Geebee (Bangladesh) Limited Extended Unit.

FS SFB 02 Karnaphuli EPZ Chittagong
(22.278980, 91.789511)
8th November 2018

Observations

Column Layout

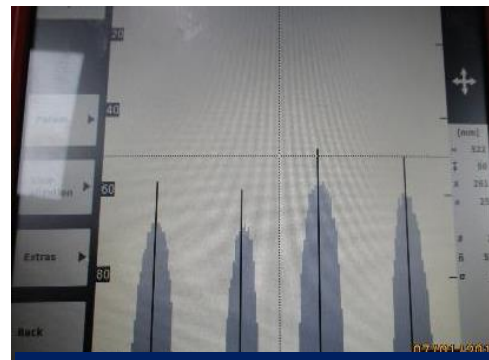
4 nos. of rebar instead of 5 nos. at C-2 type column.

Number of rebar for C-2 column does not match with column schedule. 12 nos. of rebar are found by ferro scan whereas 16 nos. of rebars are shown in column schedule. Also size of C-8 type column found 500 mm instead of 750 mm in long direction and size of C-10 & 12 type column found 260 instead of 380 mm in short direction. Also, mismatch found in beam layout.

Windows on 2nd & 3rd floor

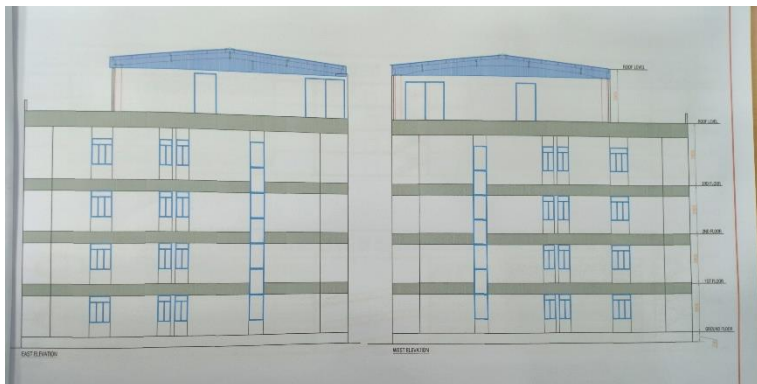
Sagging was found on windows grills on the 2nd & 3rd floors. Engineering investigation is needed to determine whether it is due to the extra load imposed from BUS bar or Cable tray.

Proposed roof shed (Portal frame)

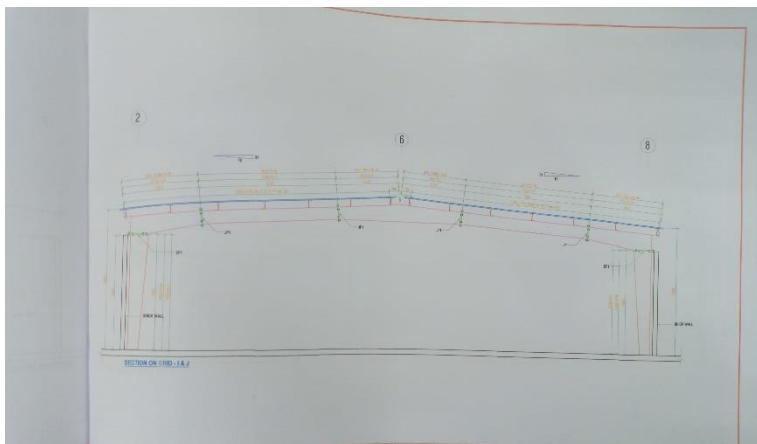
Currently the building is 3 storied. Factory has a future plan to built a shed on current roof. Proposed drawings were available during inspection. Factory engineer is required to carried out a Detail Engineering Assessment considering BNBC provision prior to any extension work.

Boiler Shed

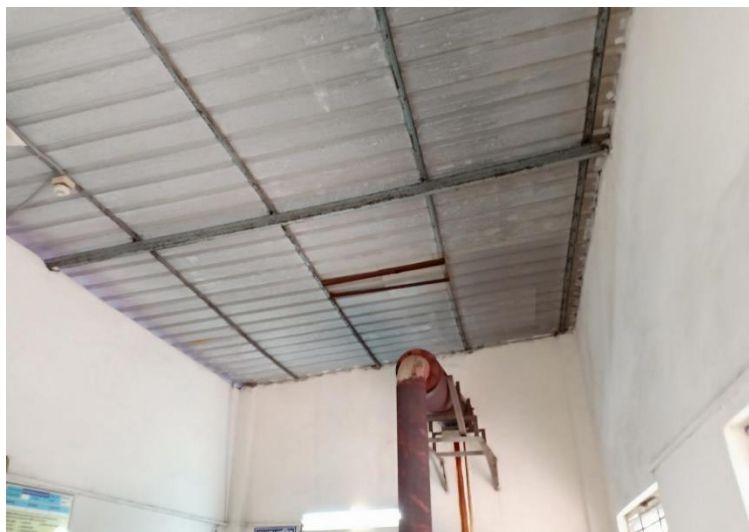
No drawings were prepared for boiler & generator shed. Building engineer is required to prepare an “as constructed” drawings which reflect the actual site dimensions with complete structural information.
